Ground Floor Plan
Flat / Unit 1
5 Double Bedrooms
Area: 173m²

Proposed Ground Floor Plan

Proposed Front Elevation (Ilkeston Road)

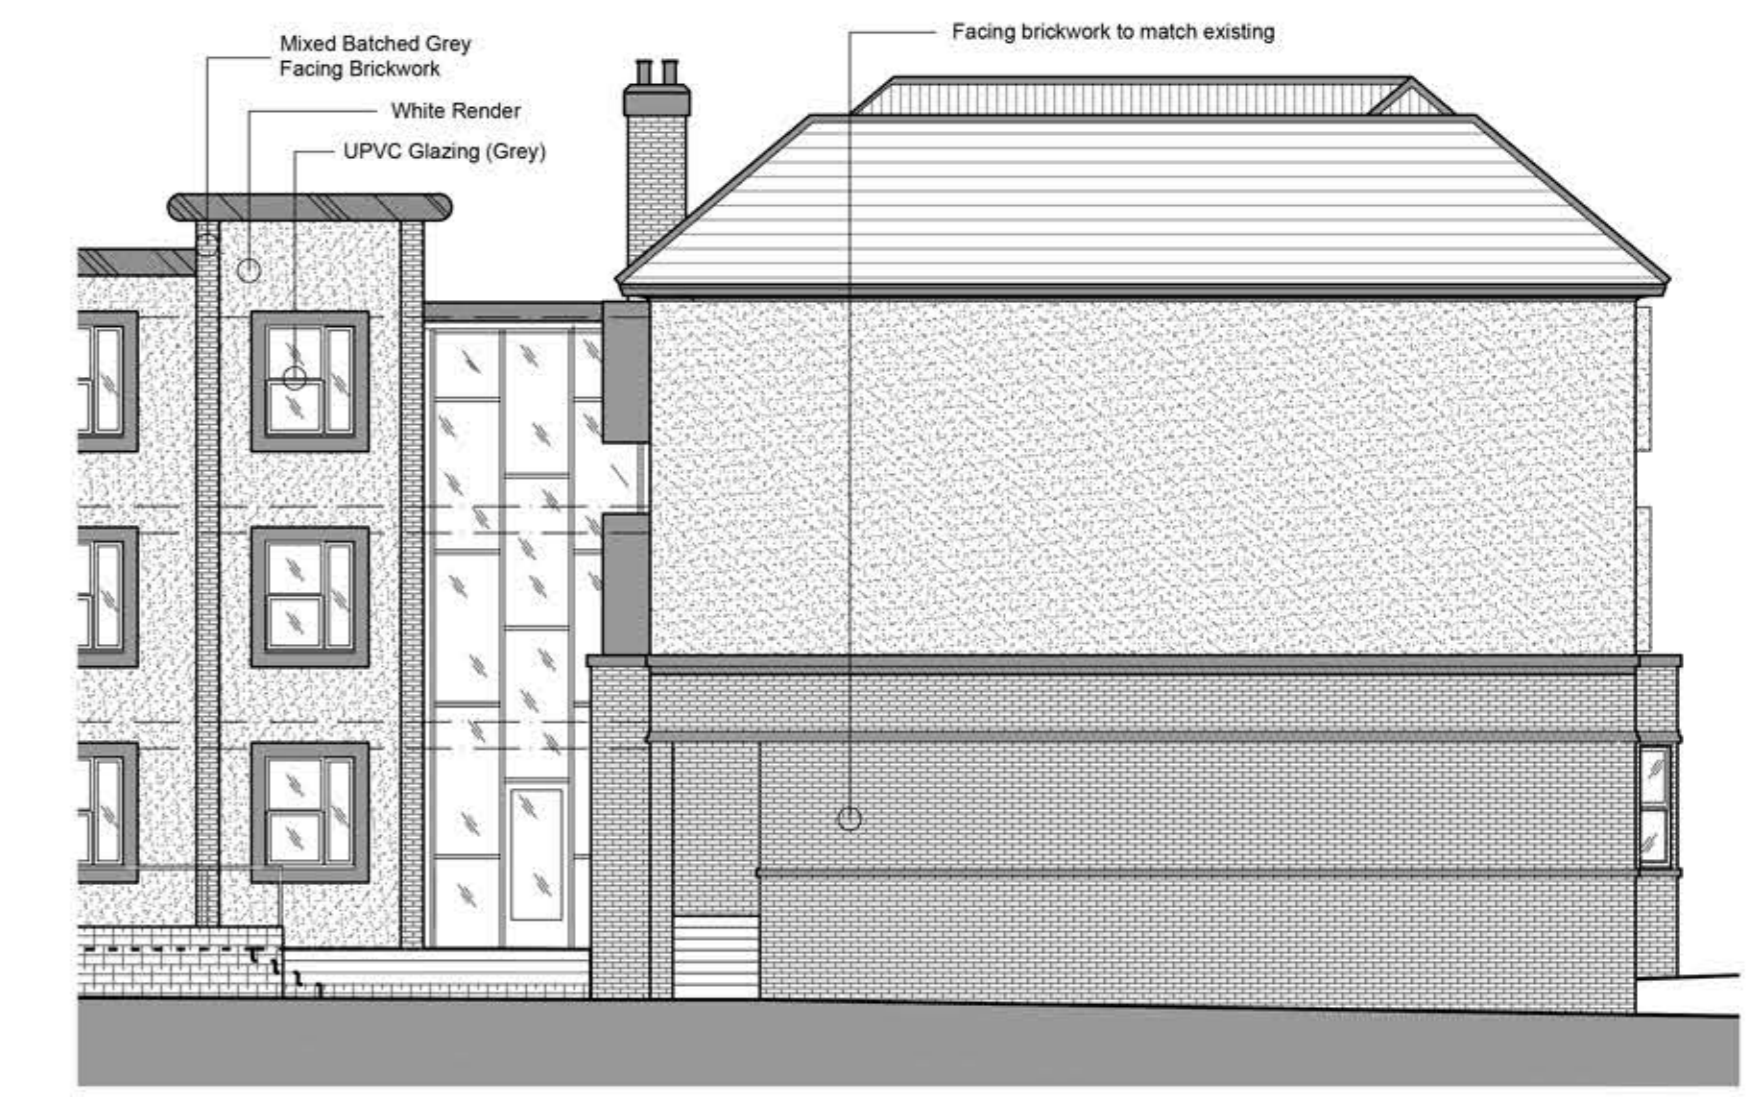
| Revision | Date | Description | By |
|----------|----------|--|----|
| I | 05.04.13 | Additional Window added to Front Elev | DL |

Proposed Window Reveal

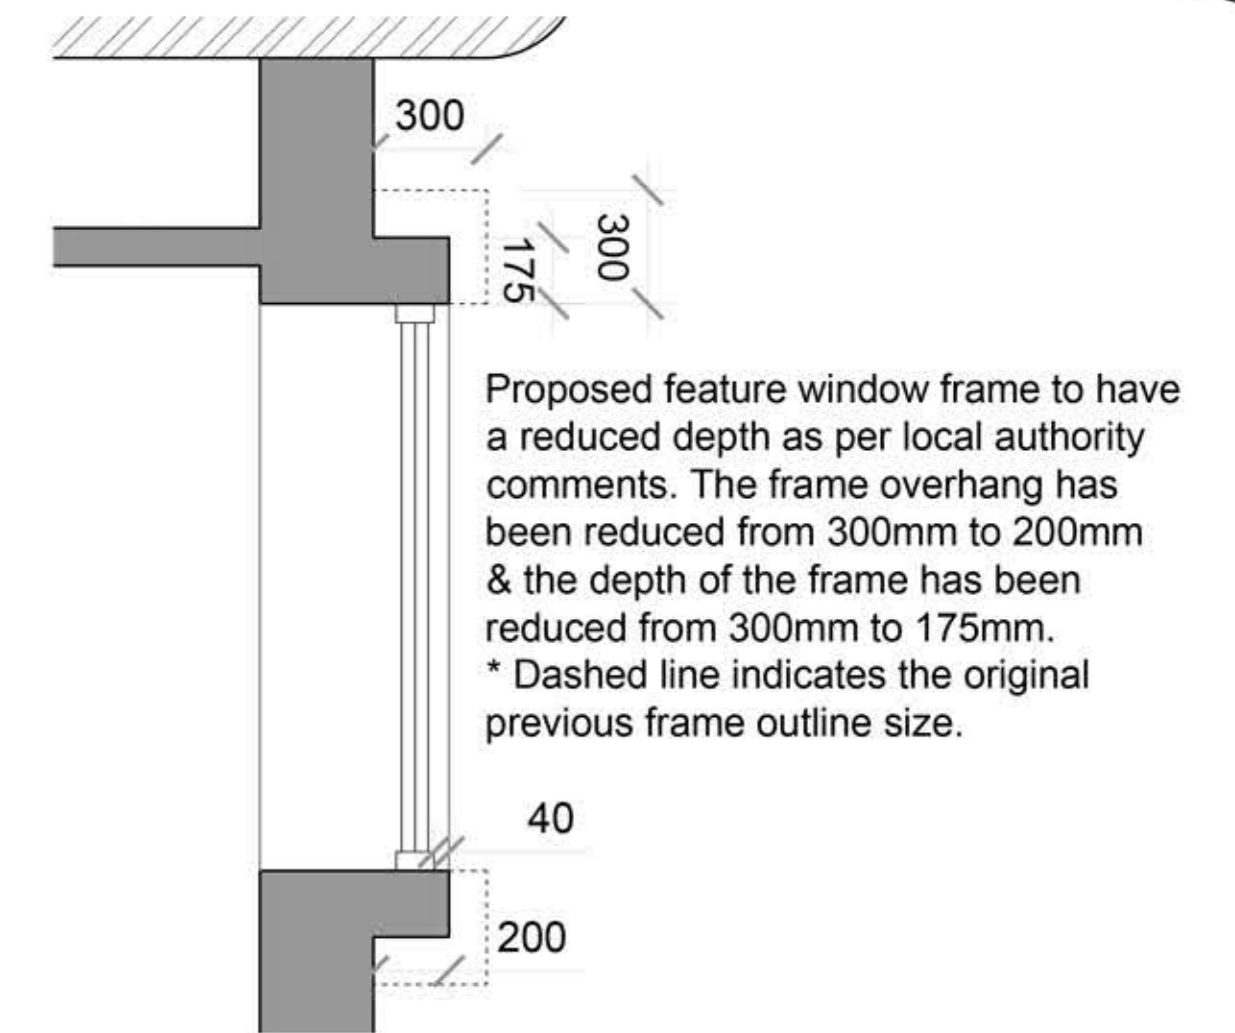
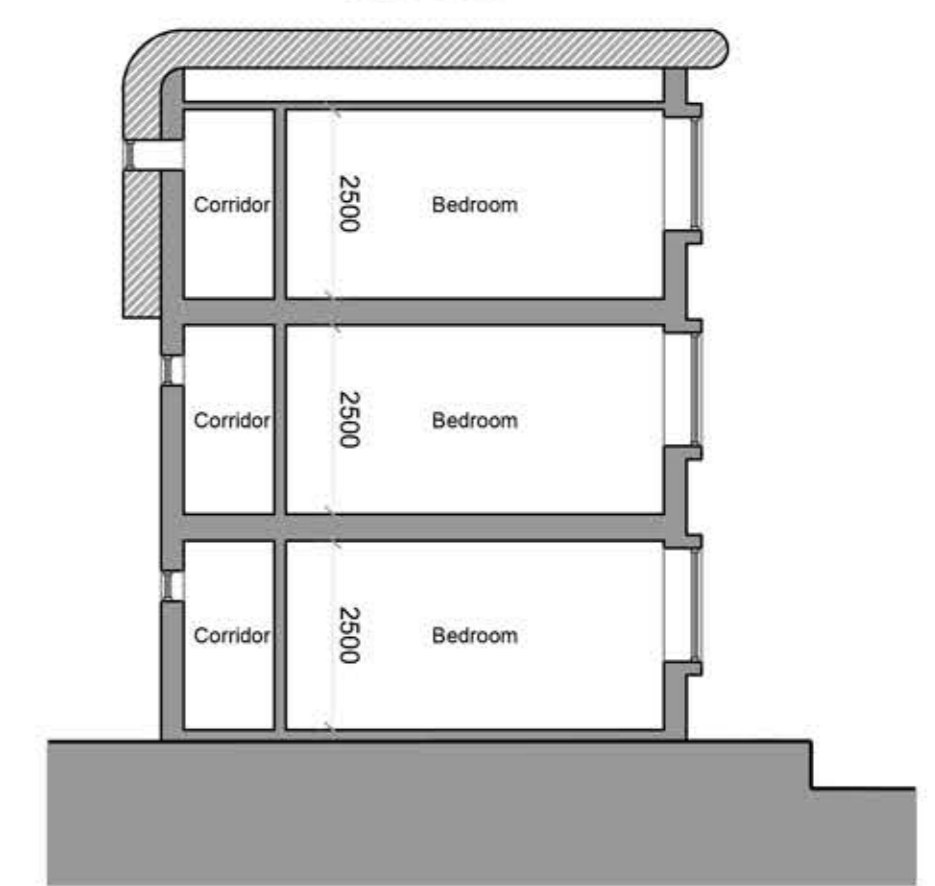
Proposed feature window frame to have a reduced depth as per local authority comments. The frame overhang has been reduced from 300mm to 200mm & the depth of the frame has been reduced from 300mm to 175mm.
* Dashed line indicates the original previous frame outline size.
